**TOWN AND COUNTRY PLANNING ACT 1990
SECTION 78 APPEAL**

**APPEAL BY GREAT LAKES UK LTD
REF: APP/C3105/W/20/3259189**

**CHESTERTON, BICESTER
OXFORDSHIRE OX26 1TE**

**VOLUME 2
APPENDICES TO THE PROOF OF EVIDENCE**

Drainage Layout Sheet 1

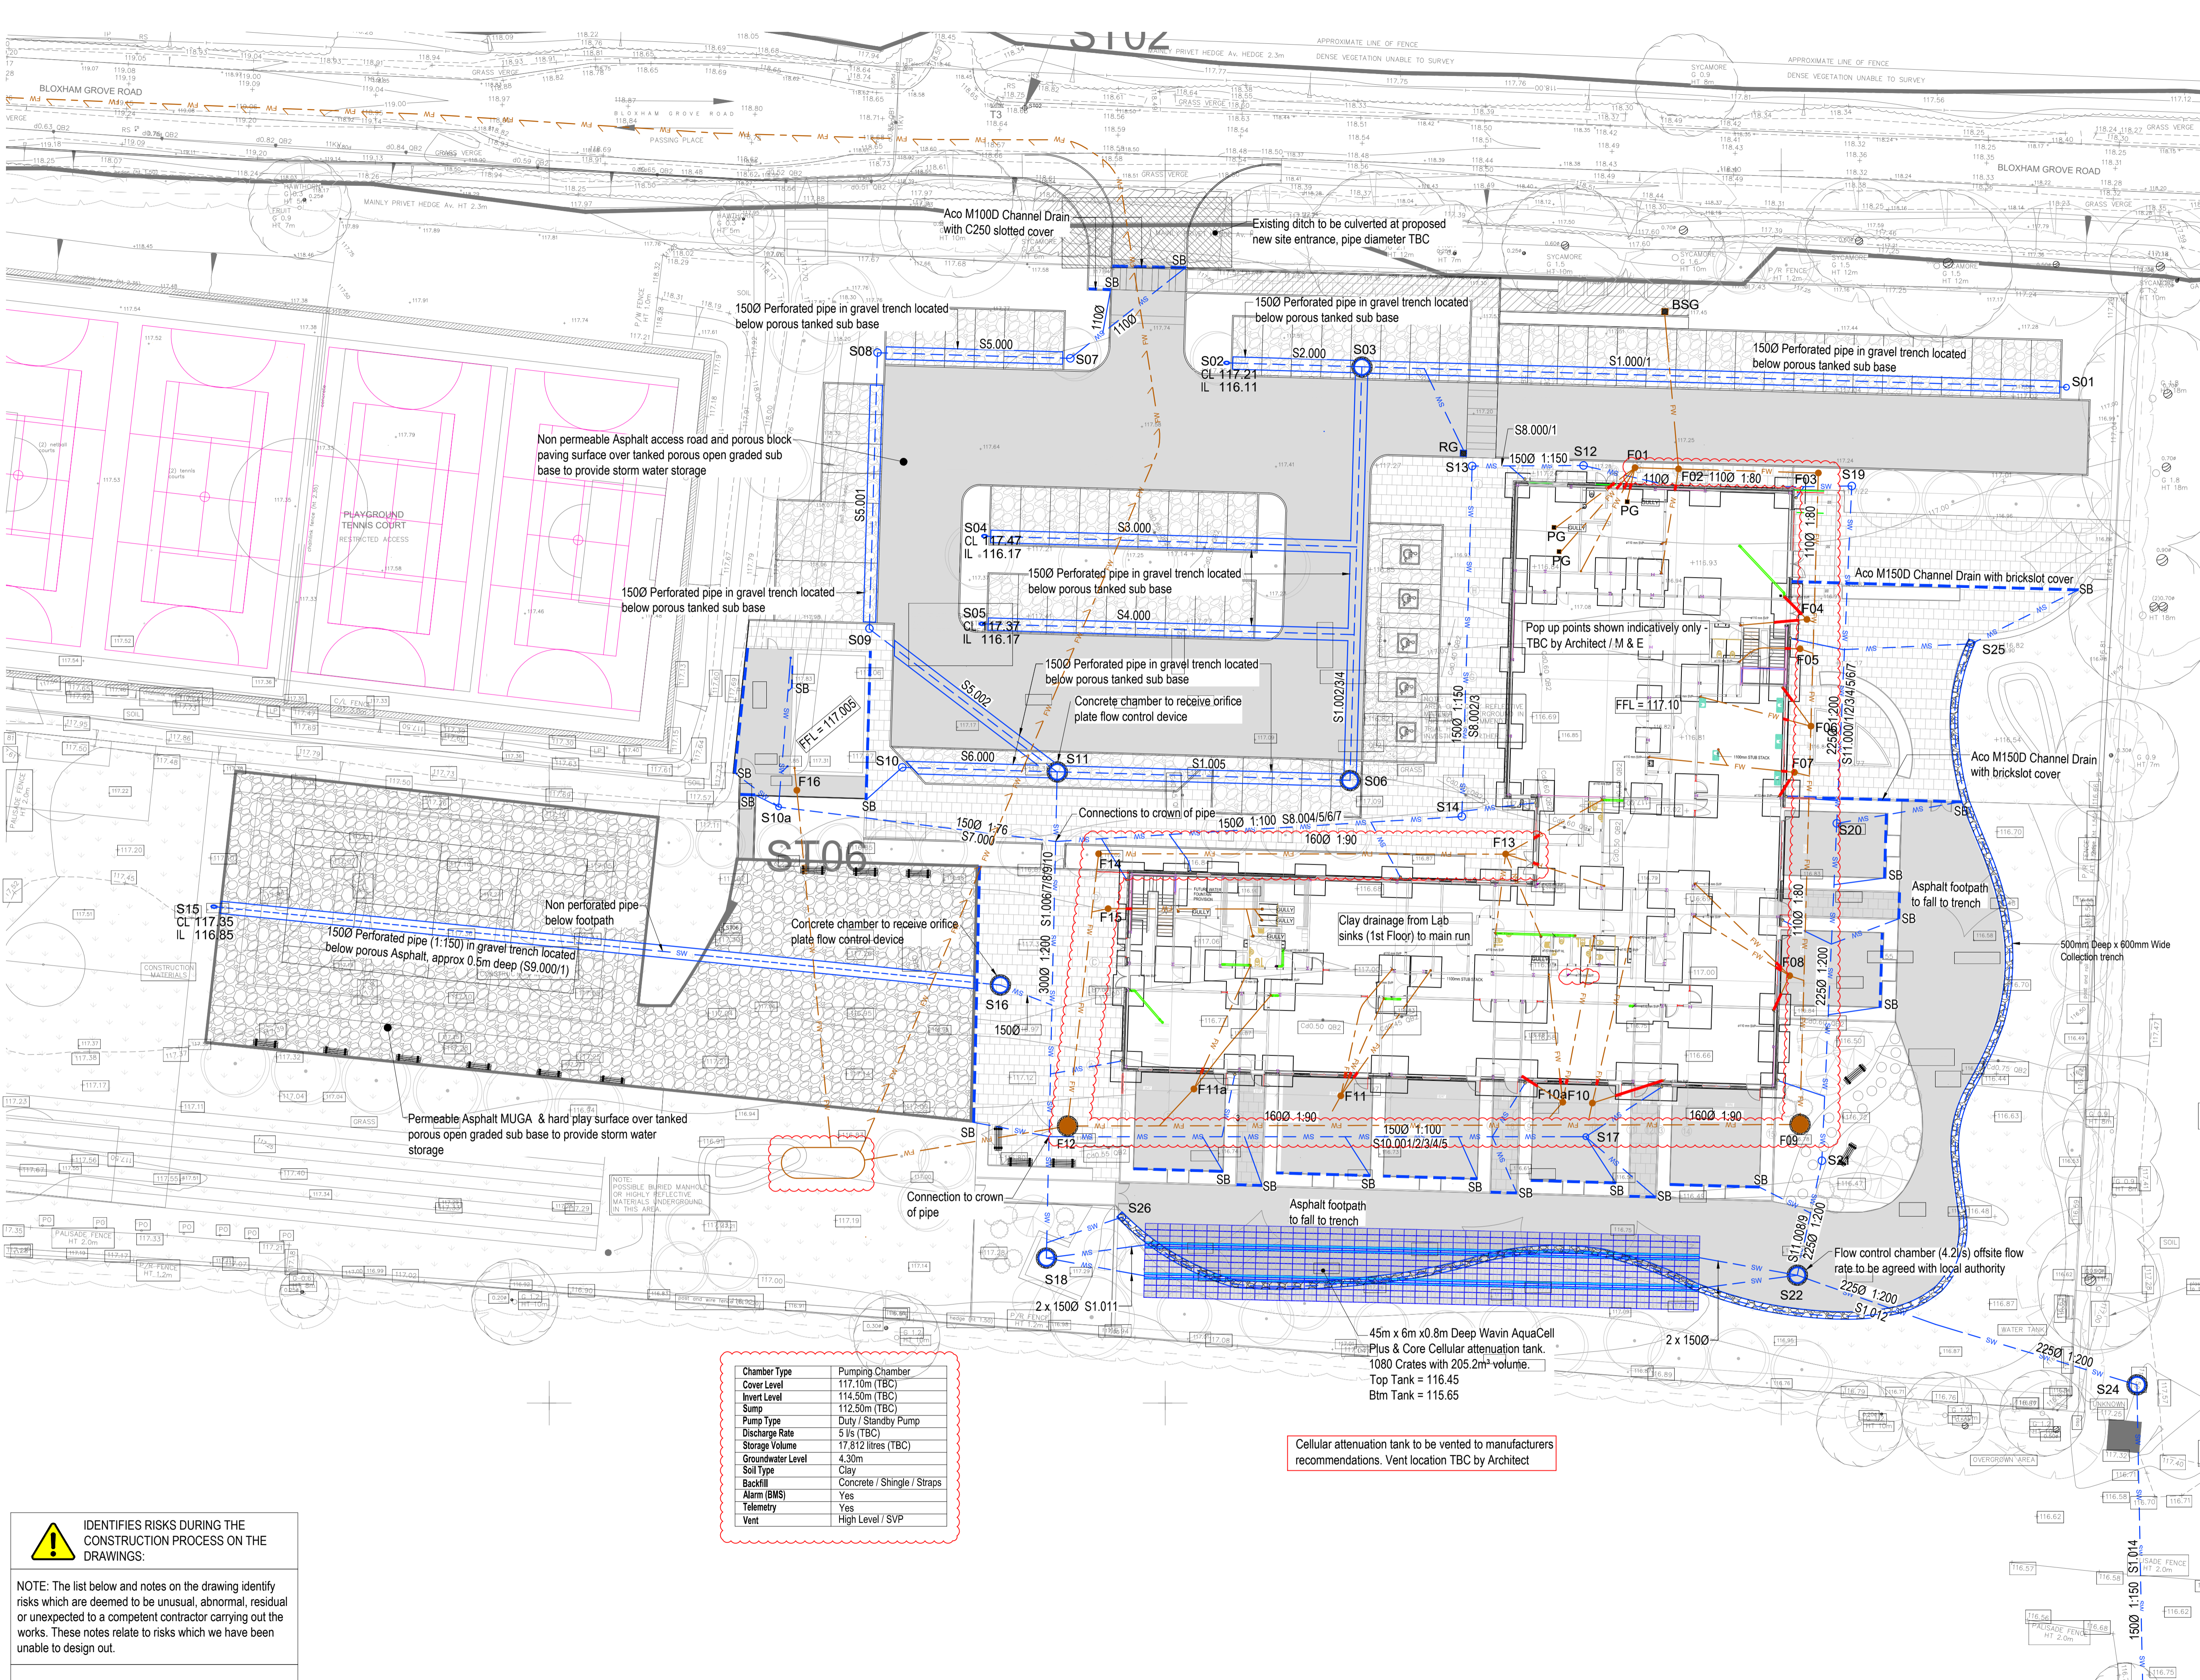
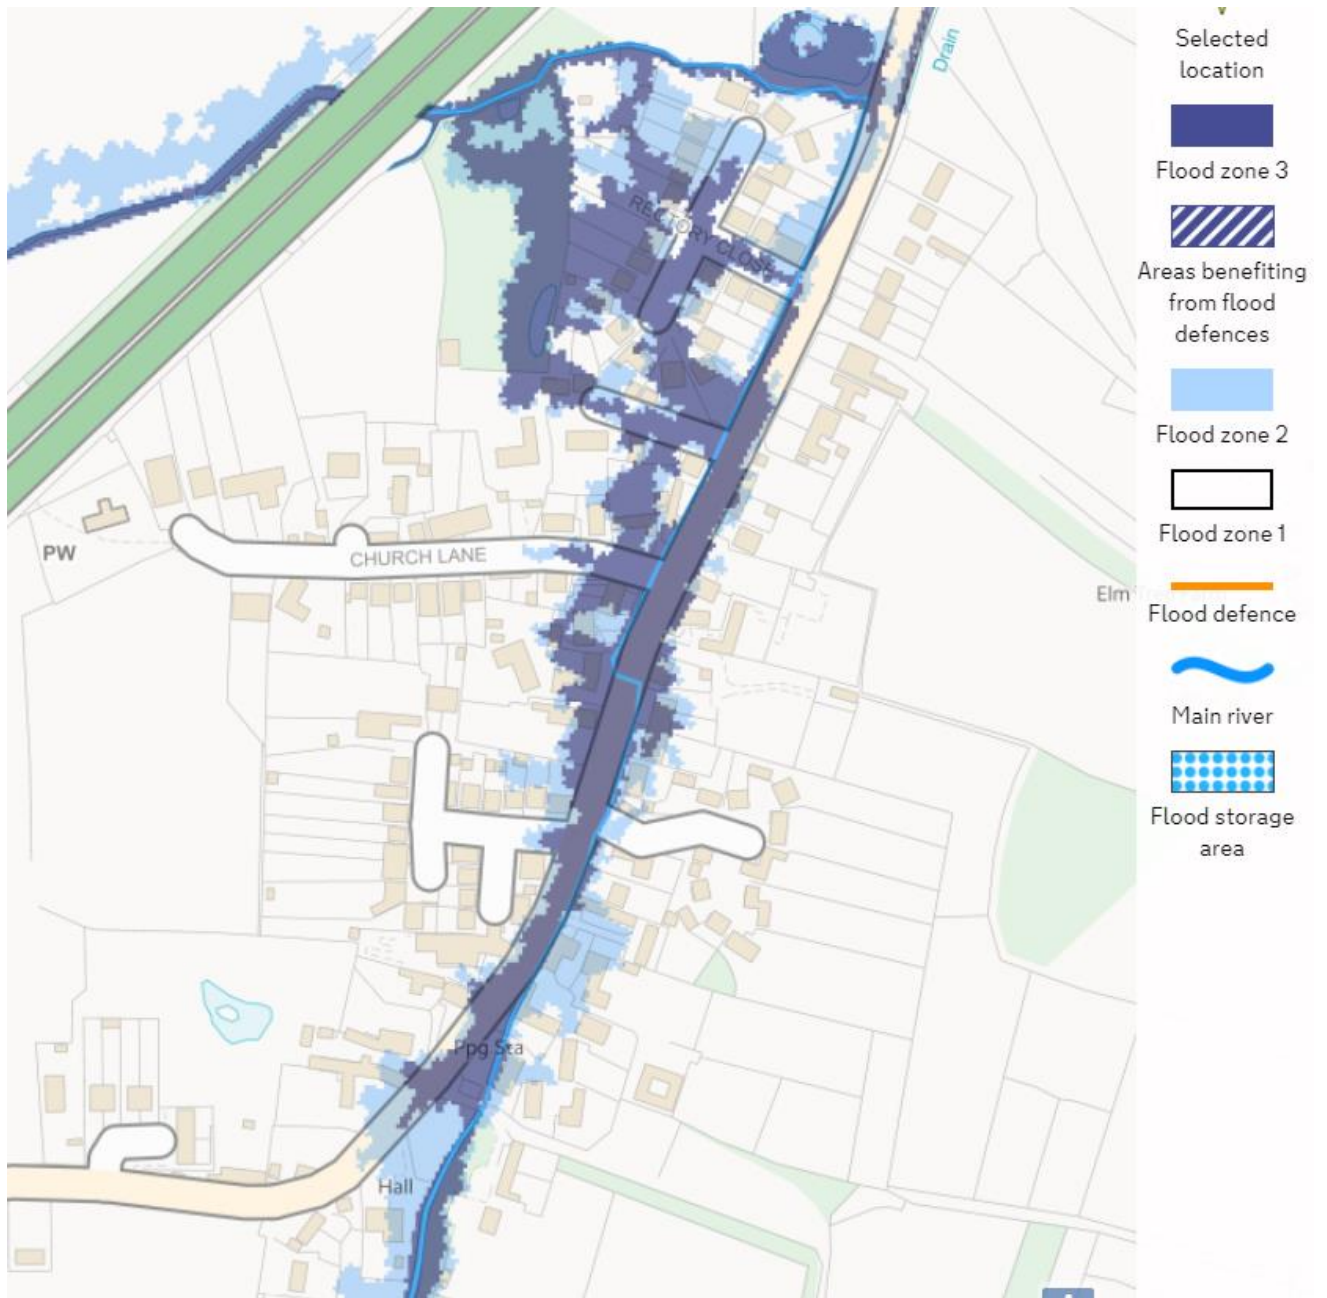
Happy New Year and thank you for your letter and calculations. Would it be possible to get an updated plan with the invert and cover levels on to help with our review?
